MEMORANDUM

Re: **RC-19-001 – RCOZ C Special Exception for a Residence
4586 South Thousand Oaks Drive**

Applicant: **Gary and Nazeli Manukyan**

Zone: **R-1-10 / RCOZ**

PRINTED:
4/30/2019
4:05:16 PM

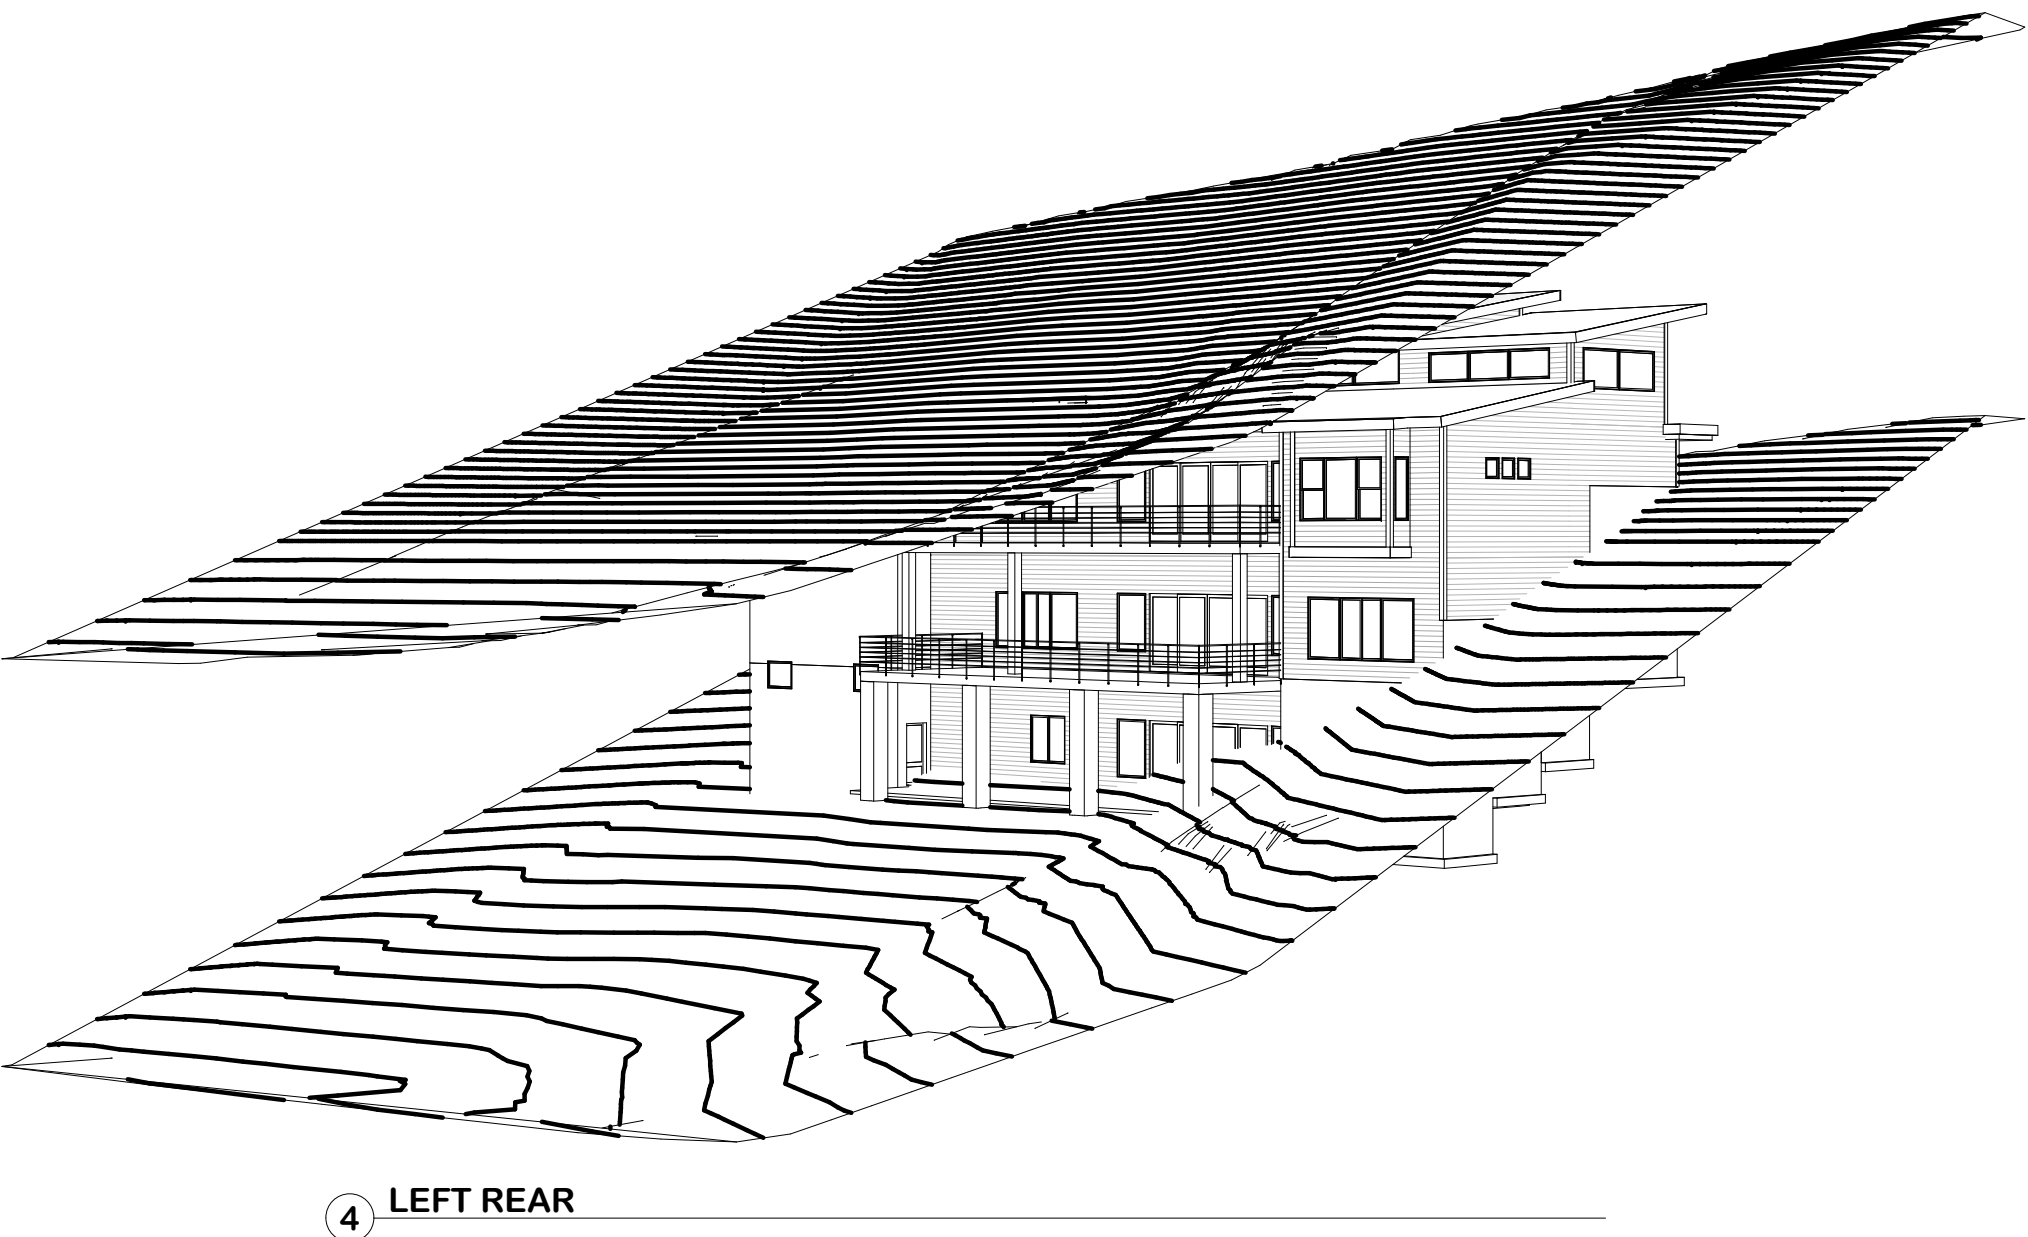
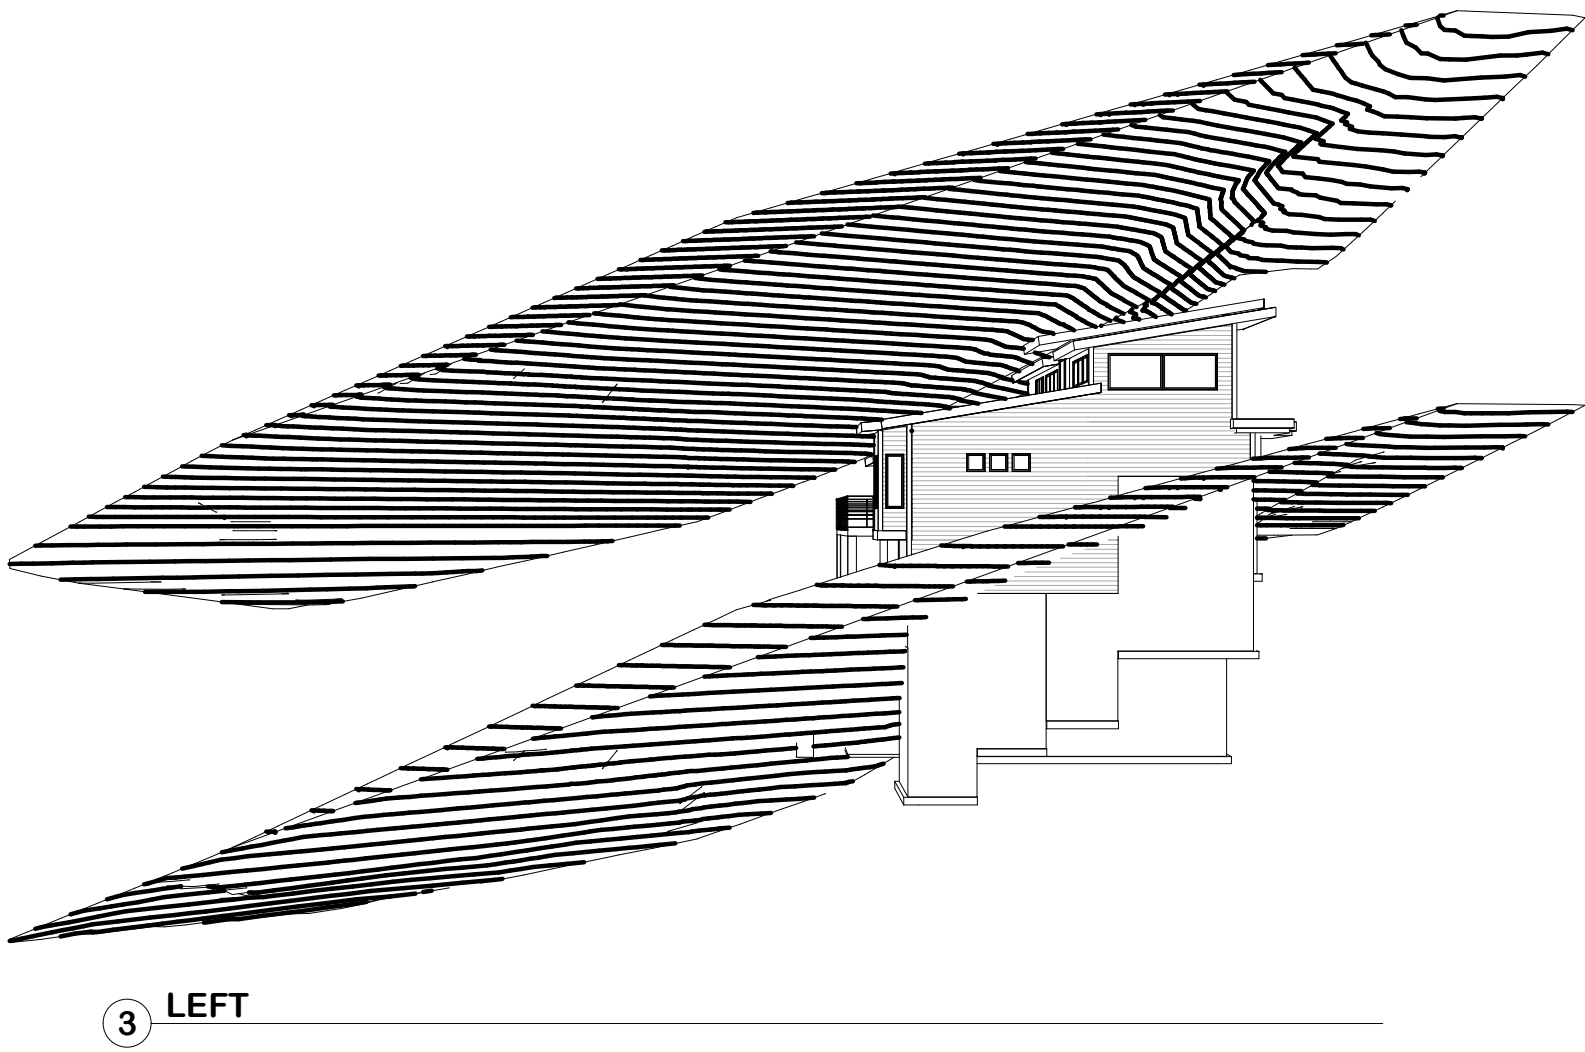
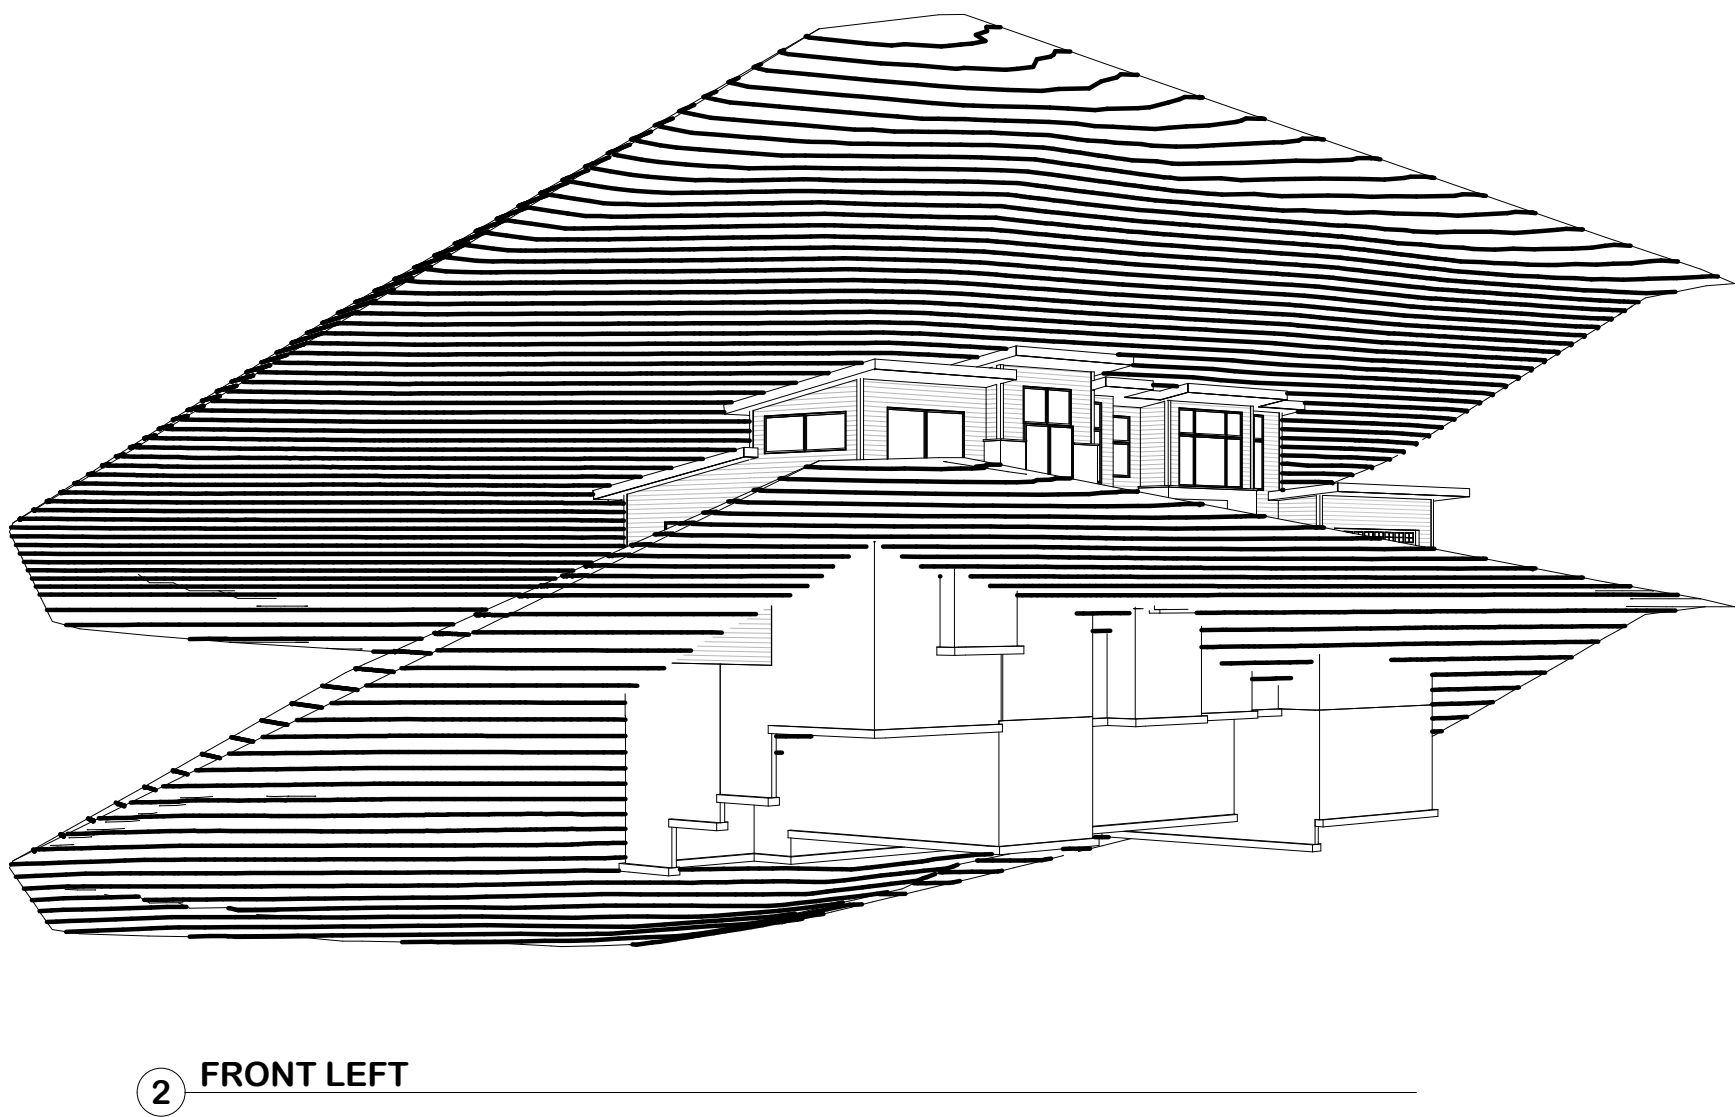
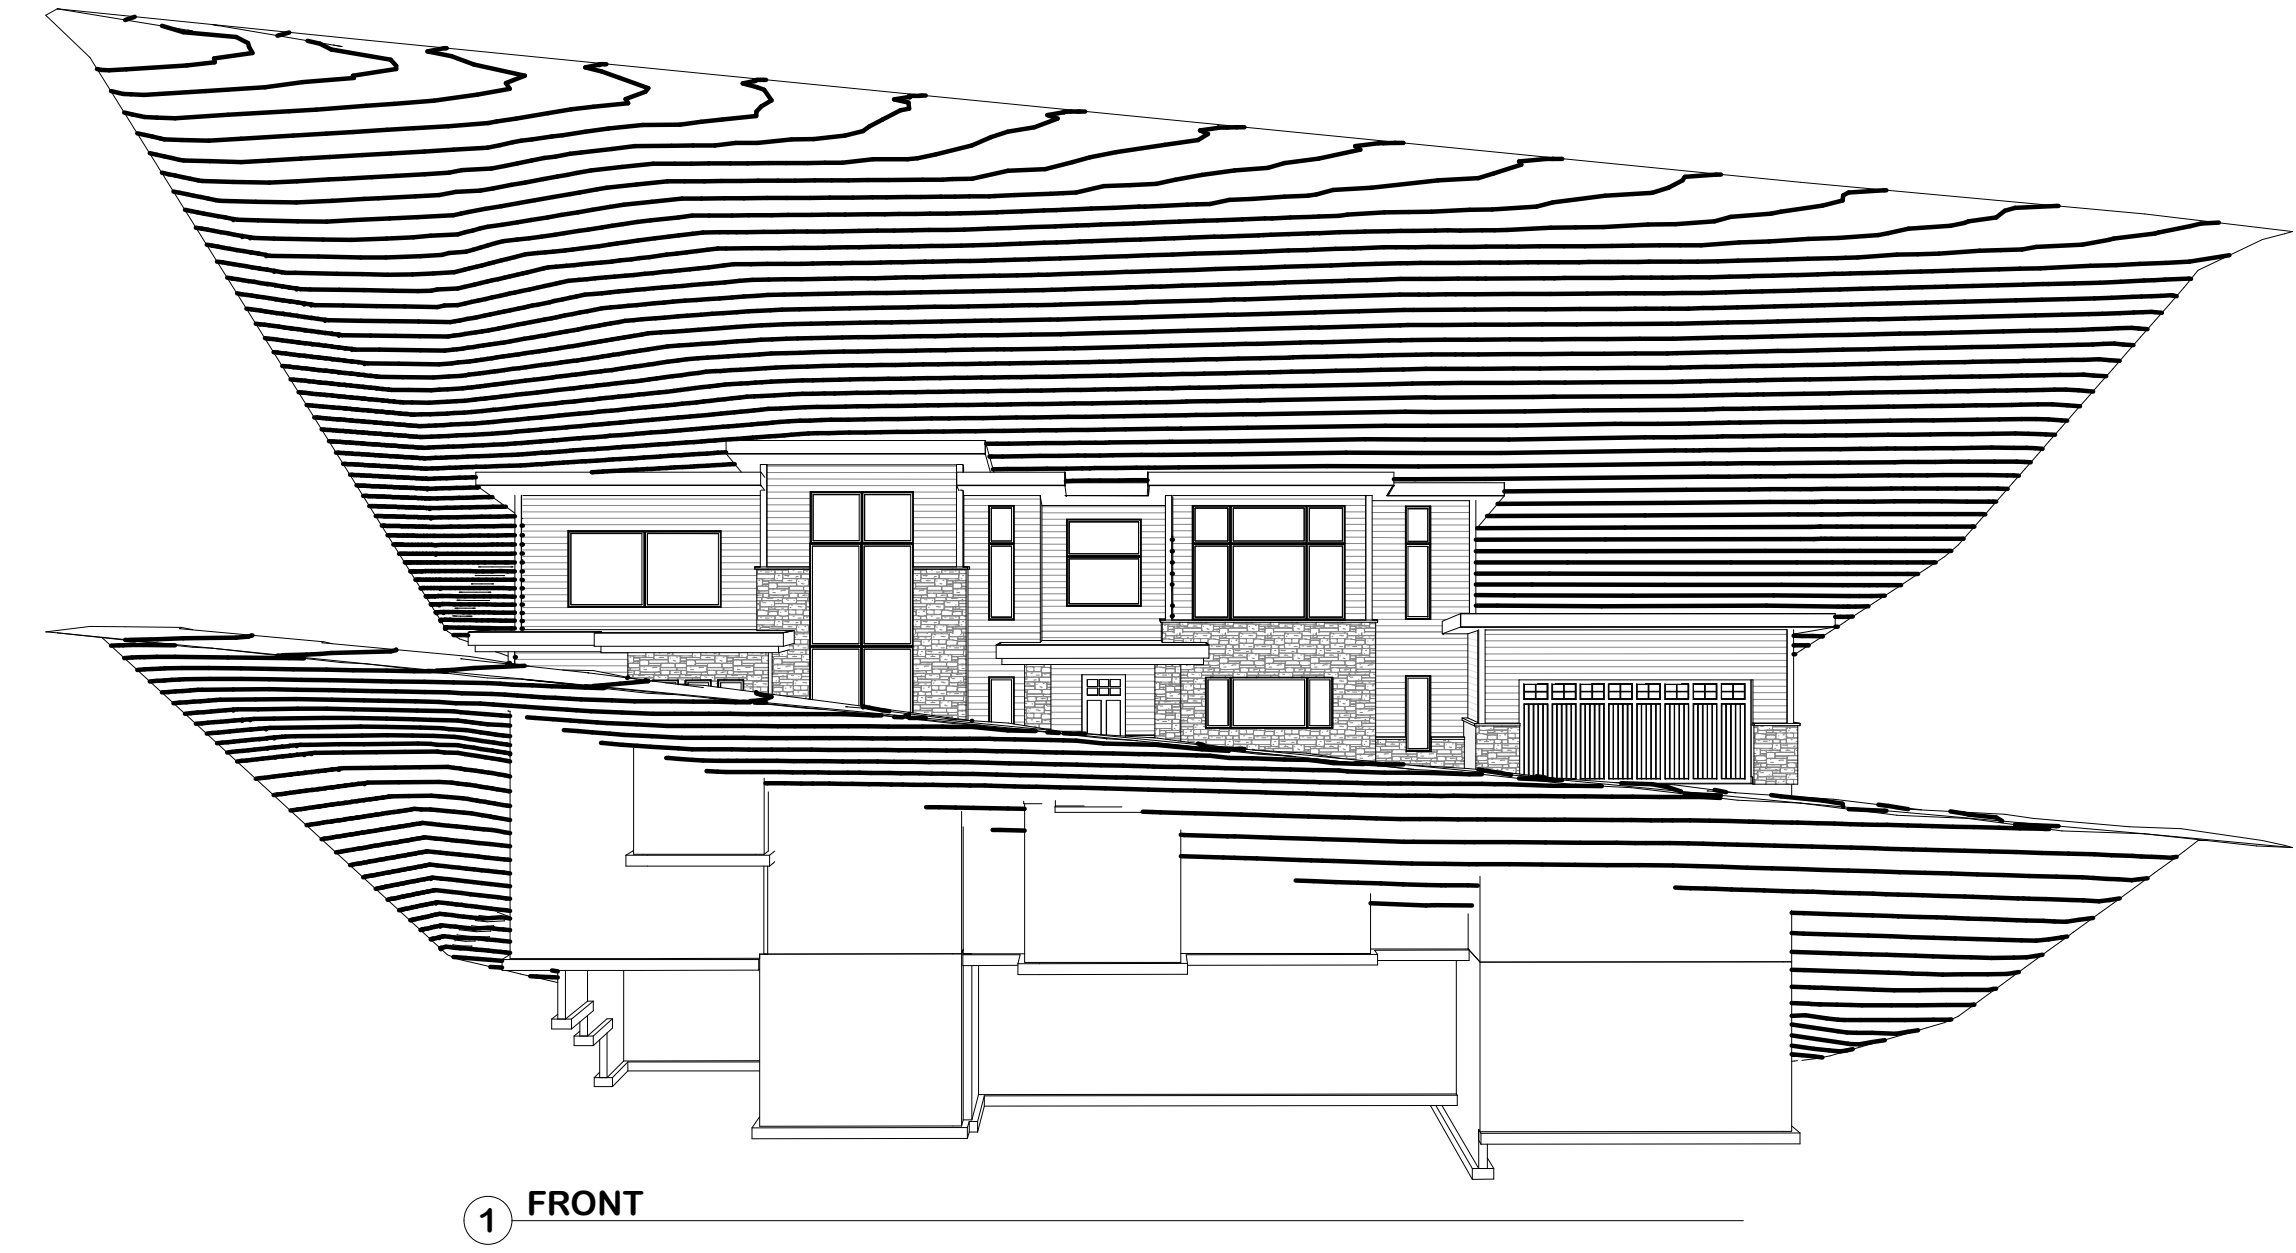
The applicant provided a topographical offset diagram that shows that no point of the home will exceed 40 feet above original grade. A portion of the rear façade, at about the midpoint of the length of the lot, is right at 40 feet – owing to the concave shape of the lot. However, much of the building falls well below the 40 foot height limit imposed by RCOZ C. See Attachment
